Access Compliance Report

Public Rights-of-Way

(Curb Ramps)

Intersection ID: 3147	Main Street: BROWNESTONE_VIEW_DR	Cross Street: MINERAL_RIDGE_WY	Location: N
ADA ID: 22E98C903A70	Ramp Type: Perp	Initial Pass/Fail: Fail	Overall Compliance: No
Severity Score: 36.25			
Codes/Mitigation Info/Possible Solution		Field Measurements/Component Compliance

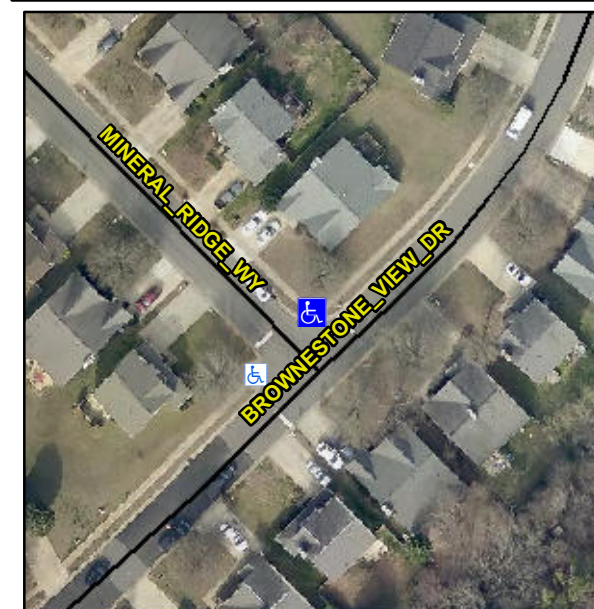
Not Found, R304.5.1, R304.5.3

Compliance	Description	Data	Compliance	Description	Data
N/A	Ramp Length (in)	94.0	Yes	Ramp Slope (%)	5.0
No	Ramp Width (in)	30.0	No	Ramp XSlope (%)	3.1
N/A	Flare Type LT	N/A	N/A	Flare Type RT	N/A
N/A	Flare Slope LT (%)	N/A	N/A	Flare Slope RT (%)	N/A
N/A	Flare Traversable LT?	N/A	N/A	Flare Traversable RT?	N/A
N/A	Landing Length (in)	N/A	N/A	DWS Provided?	N/A
N/A	Landing Width (in)	N/A	N/A	DWS Contrast?	N/A
N/A	Landing Slope (%)	N/A	N/A	DWS Length (in)	N/A
N/A	Landing X Slope (%)	N/A	N/A	DWS Full Width?	N/A
N/A	Landing Curb? (Y/N)	N/A	N/A	DWS Offset (in)	N/A
N/A	Shared Landing?	N/A			
N/A	Gutter Ponding?	N/A	N/A	Gutter Slope (%)	N/A
N/A	Gutter Lip Ht (in)	N/A	N/A	Gutter X Slope (%)	N/A
N/A	Painted X Walk1?	No	N/A	Painted X Walk2?	N/A
	X Walk 1 Direction	To SW		X Walk 2 Direction	N/A
N/A	X Walk 1 Width (in)	N/A	N/A	X Walk 2 Width (in)	N/A
	X Walk 1 Slope (%)	4.9		X Walk 2 Slope (%)	N/A
	X Walk 1 X Slope (%)	6.4		X Walk 2 X Slope (%)	N/A

N/A	Ramp inside XWalk1?	N/A	N/A	Ramp inside XWalk2?	N/A
	Road Slope (%)	N/A	N/A	Clear Space?	N/A
	Road X Slope (%)	N/A	N/A	Clear Space to XWalk (in)	N/A
N/A	Any Obstructions?	N/A	N/A	Storm Grate/Utility Hazard?	N/A
	Obstruction Type			Storm Grate/Utility Type	
		N/A			N/A
			Yes	Surface Condition? (G/P)	Good

Remove & Replace Entire Ramp.
